## Product Change Notification / SYST-11ARMC394

12-Oct-2022

ERRATA - KSZ9897R Silicon Errata and Data Sheet Clarification

**FIGURE 1: IEEE DOCUMENT PAGE 6**

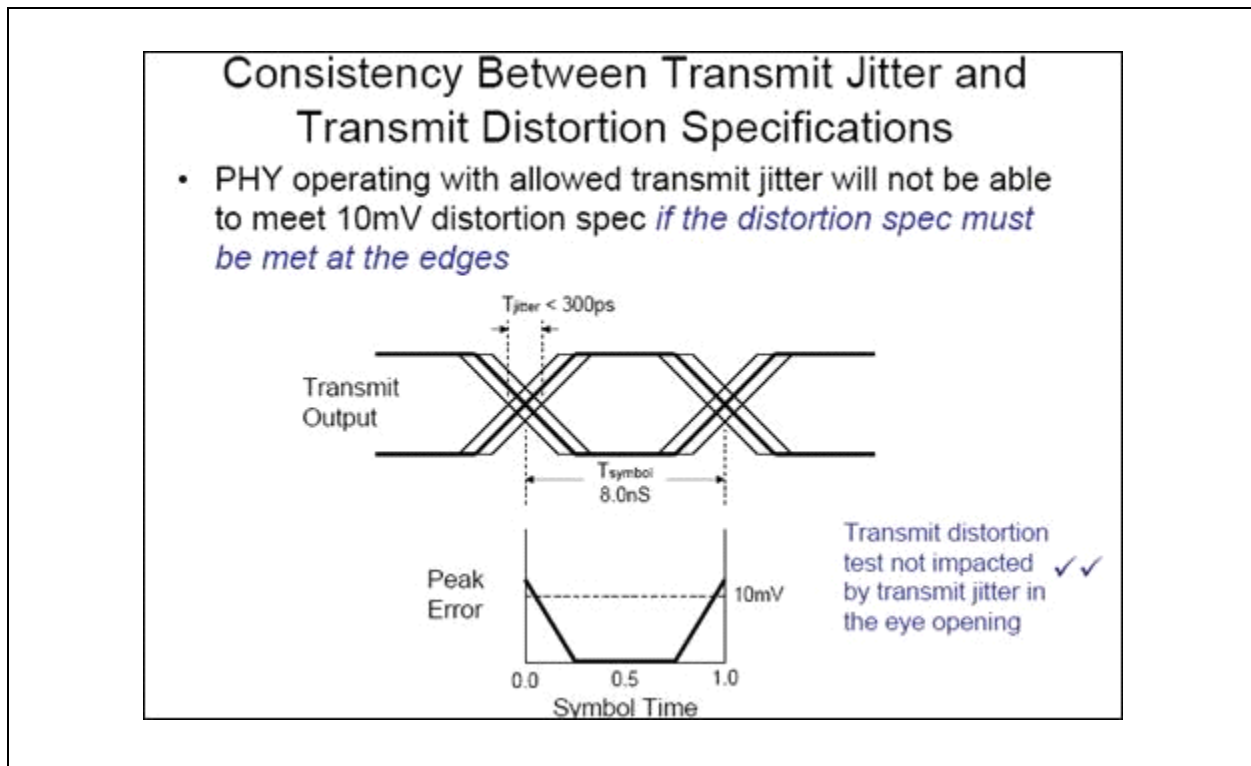
- On page 6, a contradiction between Transmit Jitter and Transmit Distortion requirements:

**FIGURE 2: IEEE DOCUMENT PAGE 7**

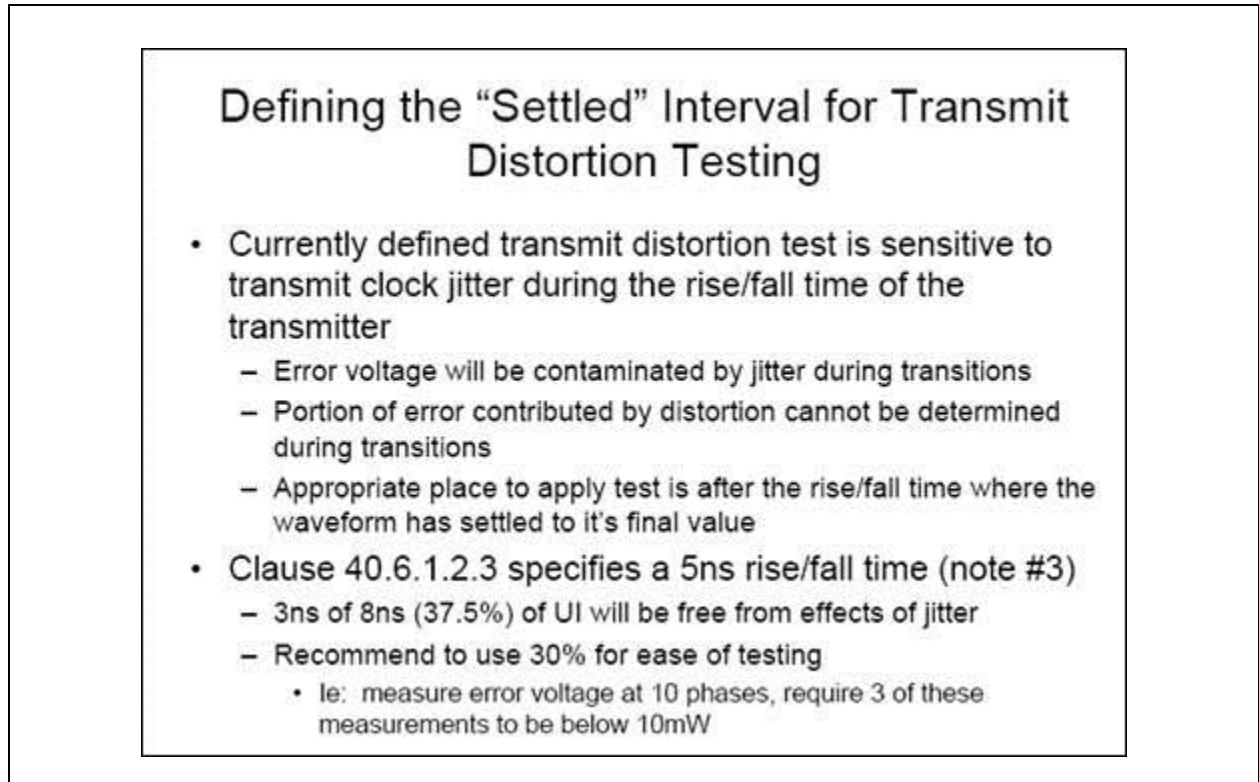
- On page 7:
  - The transmit distortion test is sensitive to transmit clock jitter during the rise/fall time.
  - It is recommended to change the requirement to use at least 30%, instead of at least 60%, of the UI within the eye opening for the <10mV peak transmitter distortion.
